Service Bulletin

No. : MZ07-060

Model: SR4001, SR5001 SR7001, SR8001

Subject: A component configuration change: TUNER MODULE and FM ANTENNA only for the US version.

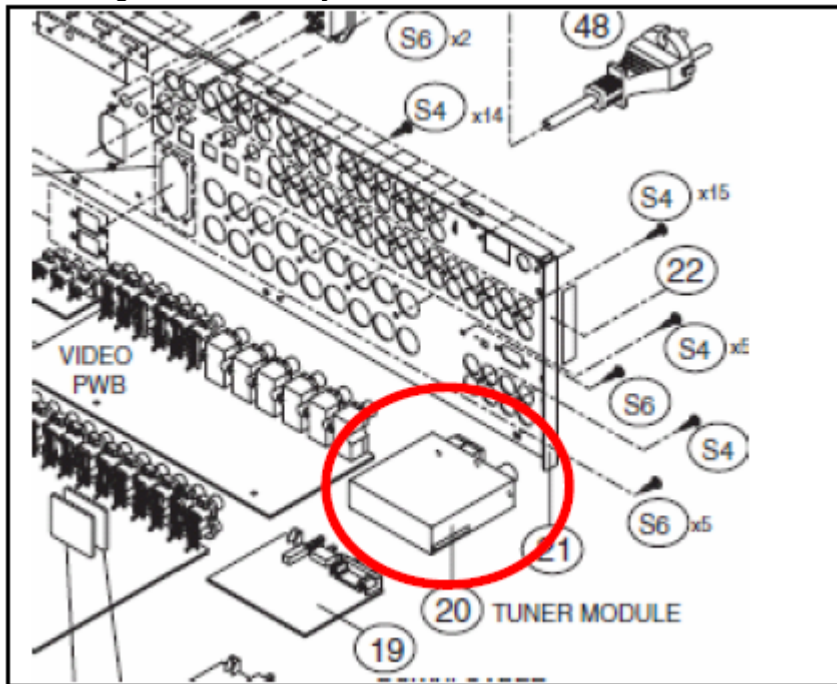
Symptom: The configuration of the FM Antenna Terminal was changed from the APL/F common connector to the F Connector.

Solution: 1. Change of TUNER MODULE
POS.NO. 20 SR4001, SR5001
POS.NO. 60 SR7001, SR8001

2. Change of accessory FM Antenna

OLD: TUNER MODULE
PART NO. 90M-AV000410R

OLD: FM ANTENNA
PART NO. 90M-ZA000210R

NEW: TUNER MODULE
PART NO. 90M-AV000570R

NEW: FM ANTENNA
PART NO. 90M-ZA000290R
